## PLAN REVIEW SHEET

Date:	08/12/14	Staff Contact:	Brian Horton
		Telephone:	704-353-0018
Petition:	2014-091		
	Time Warner Cable	Email: Attachments:	bhorton@charlottenc.gov Bus Stop Standard 60.01B

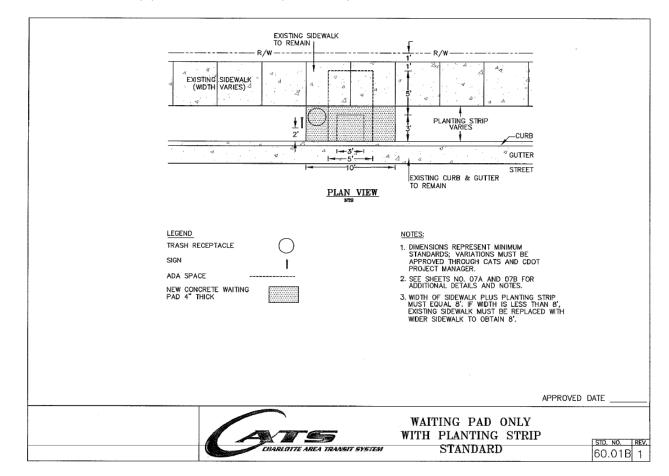
The Petitioner is requested to provide and construct a concrete waiting pad for the existing bus stop along Arrowood Boulevard at Crescent Executive Drive. In light of the retained planting strip, the petitioner should use standard detail 60.01B.

Below is an image of the standard detail (60.01B) for the requested bus stop pad. The site plan may either show the conceptual location of the improved bus stop on Arrowood Road, or alternatively, include a development note to locate the bus stop pad during the development review and permitting process.
